PRODUCT CHANGE | 7" X 9" POCKET

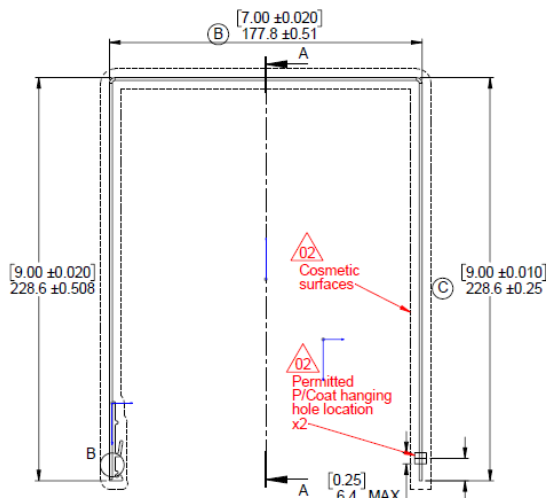
- Pocket will be powder coated both inside and outside.
- Holes added to pocket 12" from each side for improved powder coat process.
 - Unnoticeable once installed but can be plugged using RCCP-7200-075000.
